BELLEFONTE COMBINED LICENSE APPLICATION – RESPONSE TO  
ENVIRONMENTAL REPORT REQUEST FOR ADDITIONAL INFORMATION –  
SOCIOECONOMICS/ENVIRONMENTAL JUSTICE

ENCLOSURE  
RESPONSE TO ENVIRONMENTAL REPORT REQUESTS FOR ADDITIONAL INFORMATION  
SOCIOECONOMICS/ENVIRONMENTAL JUSTICE

**NRC Review of the BLN Environmental Report****NRC Environmental Category: SOCIOECONOMICS/ENVIRONMENTAL JUSTICE****NRC RAI NUMBER: 2.5.2-1 and 4.4.3-1**

ATTACHMENT 2.5.2-1  
TENNESSEE VALLEY AUTHORITY  
AERIAL IMAGE ILLUSTRATING THE SPATIAL RELATIONSHIP BETWEEN BLN,  
CREEKS EDGE ADDITION, AND RESIDENCES WEST OF MUD CREEK EMBANKMENT  
(NO DATE)

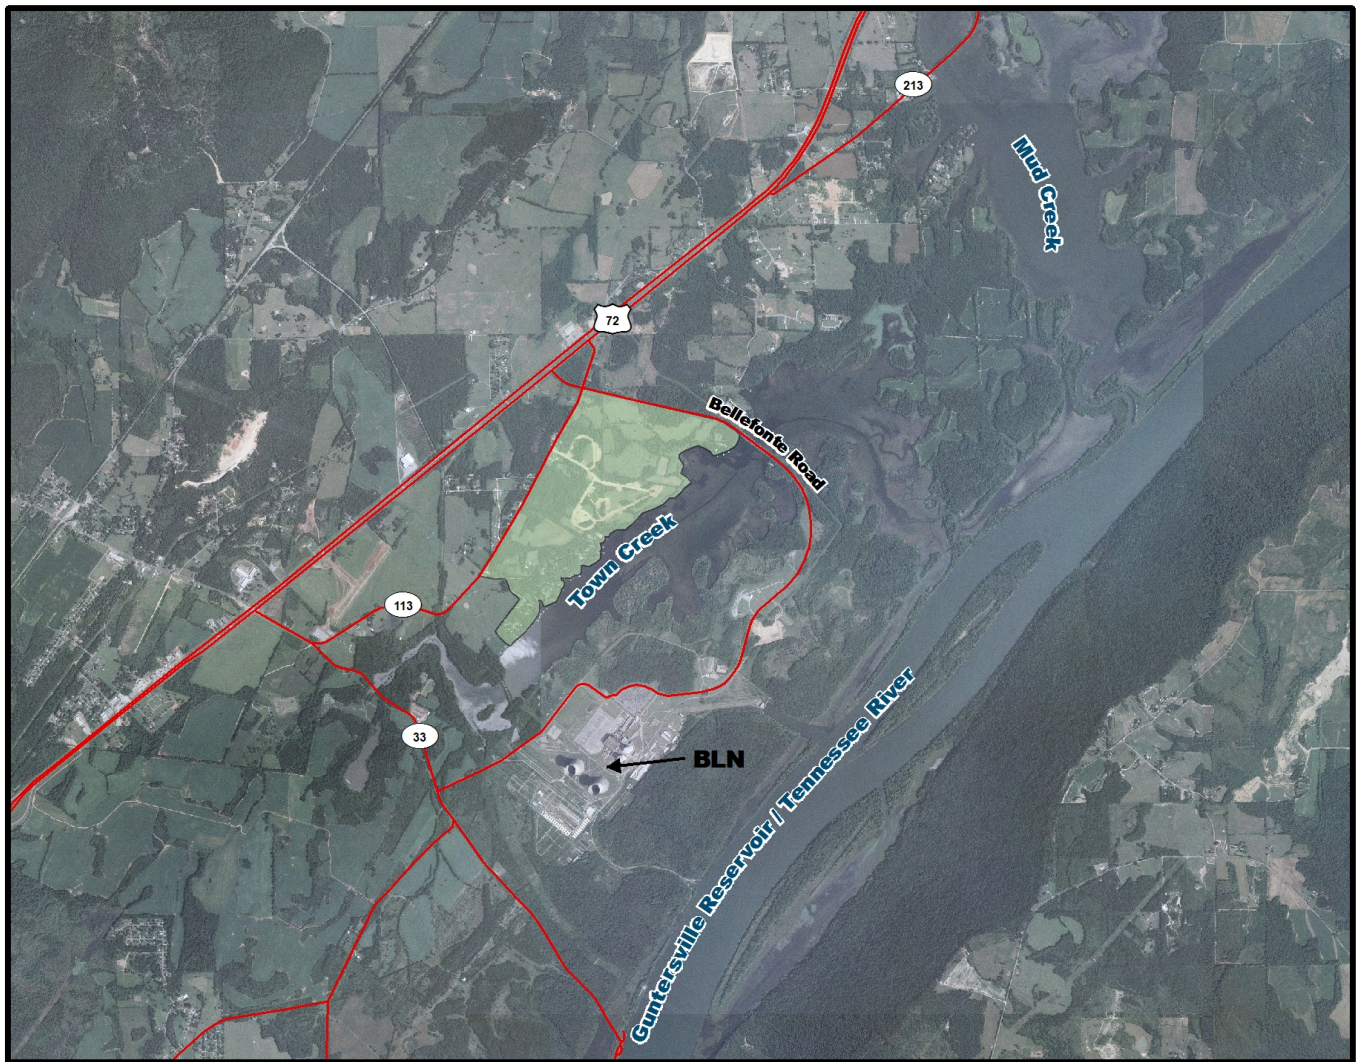
**RAI 2.5.2-1:** Provide information (demographic, housing, transportation) describing the neighborhood(s) across Town Creek from the plant site in ER Section 2.5.1.2 or 2.5.2.6. Include a map/graphic of this area at a scale that illustrates the relationship of residences to the plant and transportation routes.

**RAI 4.4.3-1:** Clarify the basis for excluding the minority population across Town Creek from the site from further consideration for impacts, including those caused by housing demand and traffic as well as noise and air quality impacts. (ER Section 4.4.3)

**2.5.2-1:** *This request has been satisfied by the TVA letter dated July 03, 2008 with the exception of the map requested and providing clarification that the entire area across Town Creek from the plant is included in the analysis, not just the Creeks Edge development.*

**4.4.3-1:** *This request has been partially satisfied by the TVA letter dated July 03, 2008 with the exception of making it clear that the analysis has included all of the residents across Town Creek from the plant – not just the residents of Creeks Edge.*

The figure provided as Attachment 2.5.2-1 to this enclosure is an aerial image with transportation routes overlaid that illustrates the geographic relationship between BLN, the Creeks Edge development, and the residential area located west of the Mud Creek embayment and south of U.S. 72 and along the BLN access roads. The residential area located on the west side of Mud Creek and south of County Road 213 is not a named housing addition. The location and characteristics of the Creeks Edge development and Mud Creek area housing are discussed in further detail in the BLN responses to NRC Information Needs SE-07 and SE-18. The minority block groups near the BLN site are discussed in the BLN response to NRC Information Need SE-28. Impacts to minorities, including those near the BLN site, are discussed in the document provided as Attachment B in the TVA letter dated May 2, 2008 (Reference 3).

Residents directly across the water, including those in the Creeks Edge development and in the area west of the Mud Creek embayment were included in the impact analyses.
